Access Compliance Report

Public Rights-of-Way (Curb Ramps)

Intersection ID: 48498	Main Street: PROVAND_CT	Cross Street: CASTLECOVE_RD	Location: SW
ADA ID: 3A24B2630B58	Ramp Type: PerpDiag	Initial Pass/Fail: Fail	Overall Compliance: No
Severity Score: 10			
Codes/Mitigation Info/Possible Solution		Field Measurements/Component Compliance

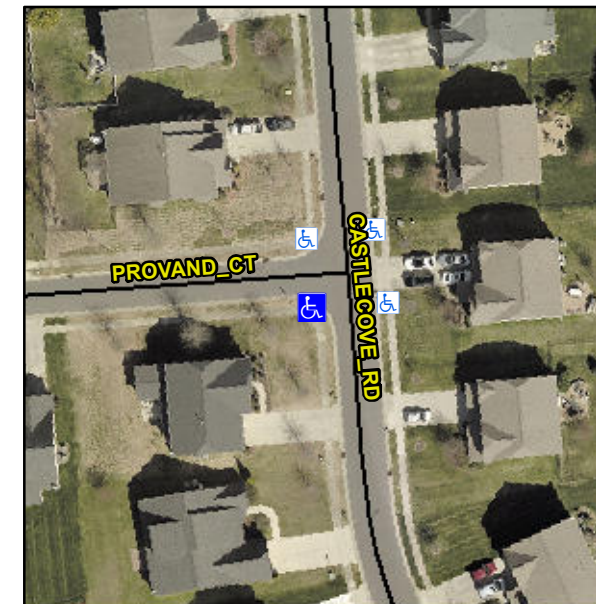
Not Found, R304.5.1, R304.5.3

Compliance	Description	Data	Compliance	Description	Data
N/A	Ramp Length (in)	46.0	Yes	Ramp Slope (%)	5.5
No	Ramp Width (in)	38.0	No	Ramp XSlope (%)	3.3
N/A	Flare Type LT	N/A	N/A	Flare Type RT	N/A
N/A	Flare Slope LT (%)	N/A	N/A	Flare Slope RT (%)	N/A
N/A	Flare Traversable LT?	N/A	N/A	Flare Traversable RT?	N/A
N/A	Landing Length (in)	N/A	N/A	DWS Provided?	N/A
N/A	Landing Width (in)	N/A	N/A	DWS Contrast?	N/A
N/A	Landing Slope (%)	N/A	N/A	DWS Length (in)	N/A
N/A	Landing X Slope (%)	N/A	N/A	DWS Full Width?	N/A
N/A	Landing Curb? (Y/N)	N/A	N/A	DWS Offset (in)	N/A
N/A	Shared Landing?	N/A			
N/A	Gutter Ponding?	N/A	N/A	Gutter Slope (%)	N/A
N/A	Gutter Lip Ht (in)	N/A	N/A	Gutter X Slope (%)	N/A
N/A	Painted X Walk1?	No	N/A	Painted X Walk2?	No
	X Walk 1 Direction	To E		X Walk 2 Direction	To N
N/A	X Walk 1 Width (in)	N/A	N/A	X Walk 2 Width (in)	N/A
	X Walk 1 Slope (%)	2.0		X Walk 2 Slope (%)	4.2
	X Walk 1 X Slope (%)	5.0		X Walk 2 X Slope (%)	1.0

Remove & Replace Curb Ramp With Two New Directional Ramps or Equivalent.
